X1 Mouse bottom layout

Bottom label and etching placement

11_17_2015

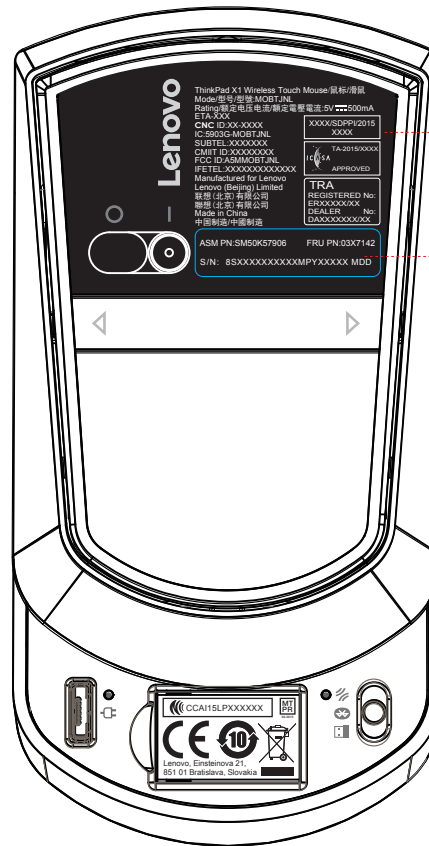
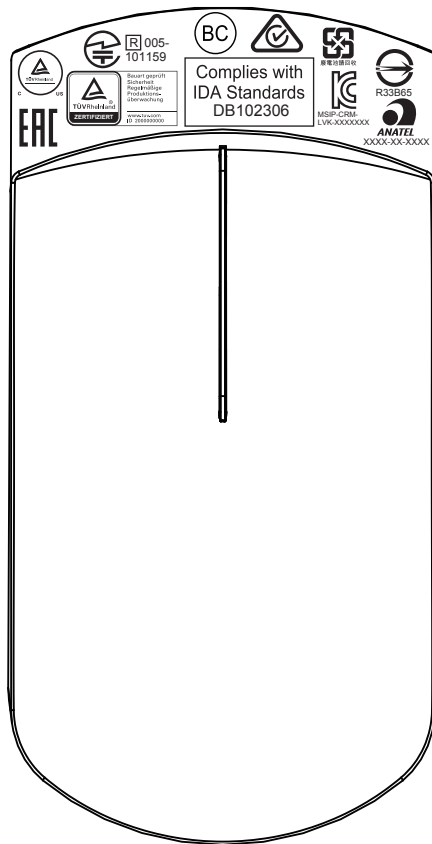
Molded-in recessed gloss letters / graphics
depth matching current ThinkPad wireless travel mouse

Matte black label (Color matching adjacent bottom surface)
numbers printed in Pantone Cool Gray 10c
Label covers hole for FW update pins

NOTE: ENTIRE LABEL MUST BE BLACK. NO WHITE AREA FOR S/N.

Molded-in recessed gloss letters / graphics
depth matching current ThinkPad wireless travel mouse
